ADDENDUM NO. 1 ISSUED BY

| | abhagen@ABHA.com www.ABHA.com | PROJECT DELAWARE TECHNICAL & COMMUNITY COLLEGE GEORGE CAMPUS EXTERIOR SIGNAGE | |

DELAWARE TECHNICAL &
COMMUNITY COLLEGE
ORLANDO J. GEORGE JR. CAMPUS
NEW CASTLE HUNDRED - NEW CASTLE COUNTY, DELAWARE

| CM-03 | SHEET NO. |

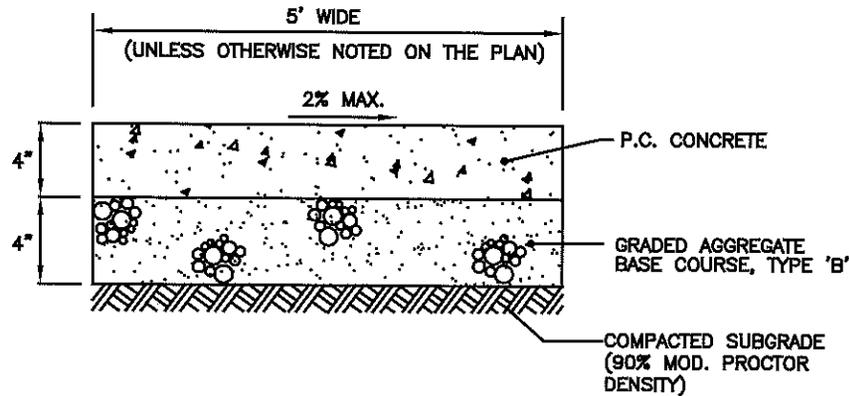
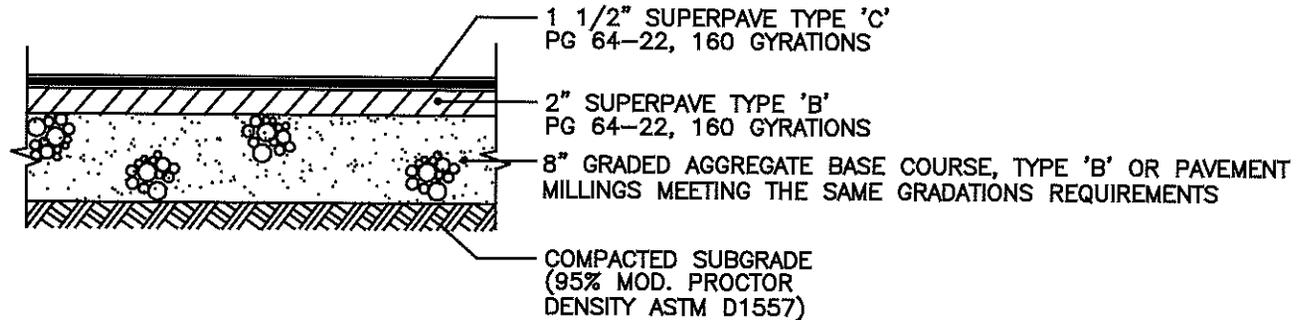
Add Drawing CM-03, attached to this Addendum. Coordinate patching and traffic control requirements for conduit crossing at Orange Street with the City of Wilmington and DelDOT.
